Word & Glory Church

Fire Marshal Division

Re: Word and Glory Church
109 E. B Street
Erwin, NC 28339

Application Number BCOM2506-0003

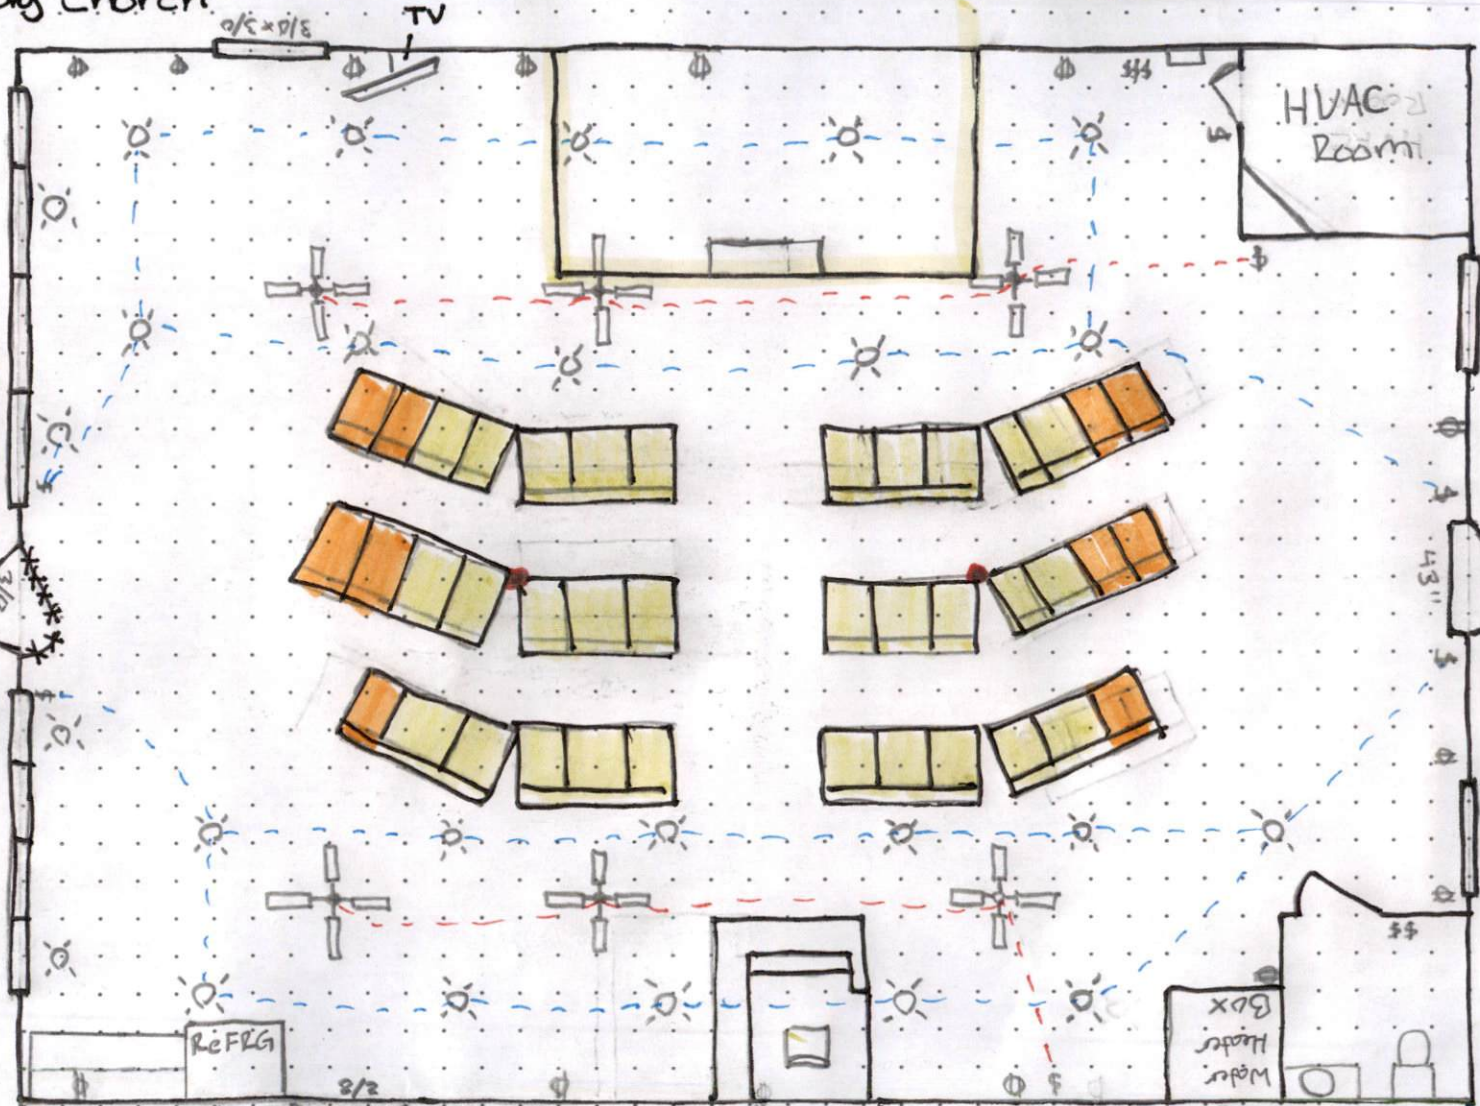
- **Panic Hardware**
 - UL 305 listed panic hardware is required on exit doors serving a room/space with an occupant load >50.
 - Both the front and rear doors will be required panic hardware and must swing in the direction of travel.

- **Means of Egress Illumination**
 - The means of egress illumination shall not be less than 1 foot-candle at the walking surface.
 - The means of egress, including the exit discharge shall be illuminated all times when the building is occupied.
 - Exit/Emergency light exit signs need to be installed at front and rear doors.
